SERVICE BULLETIN - SB030

Doc. No.:	SB030
Revision:	00
Rev. Date:	25/07/2022

SERVICE BULLETIN 30 - Exhaust manifolds welding for Rotax 912

Figure 1: Exhaust manifold

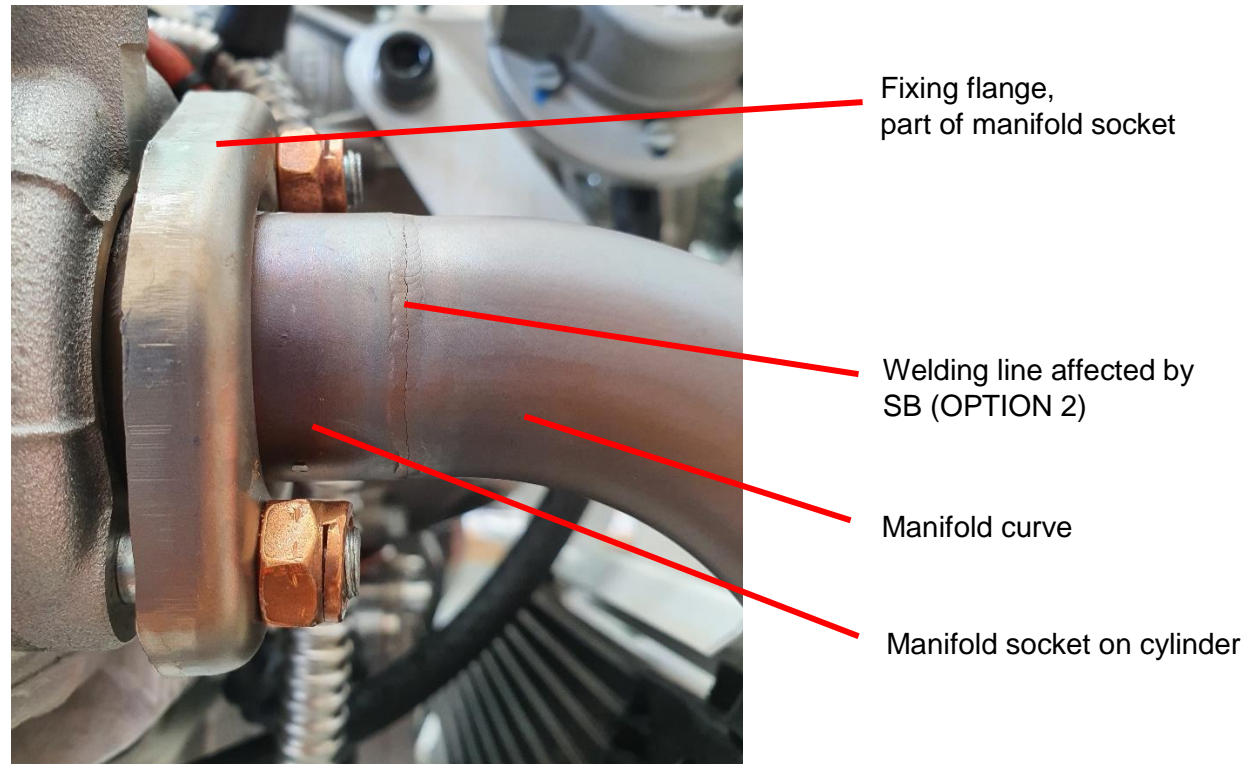
The exhaust manifolds, steel pipes from engine to exhaust muffler, which are equipped on Rotax 912 series engines of ICP aircrafts, are the parts affected by the present SB (see *Figure 1*).

The exhaust manifolds of the engine Rotax 912 model are 4 steel pipes composed mainly by two parts welded together, the ones straight connected and constrained directly to the engine cylinders and the curved ones, which is then connected to the exhaust muffler. Some welding of these parts were found cracked within few hours of flight, in different aircrafts. The part is shown in *Figure 1*.

Ferry flight of maximum 3 hours is allowed to reach maintenance facility only if accurate inspection of the manifolds welding (see *Figure 1*) is performed and no visible crack or imperfections are found.

Apply the same procedure of Option 1 excluding the installation of "spare new exhaust manifolds". Use the old manifolds and perform a new welding of the socket to the manifold curve, refer to *Figure 1*. It is necessary to request ICP an approval to perform this option; basically it must be demonstrated that the welding is operated by a certified welder workshop.
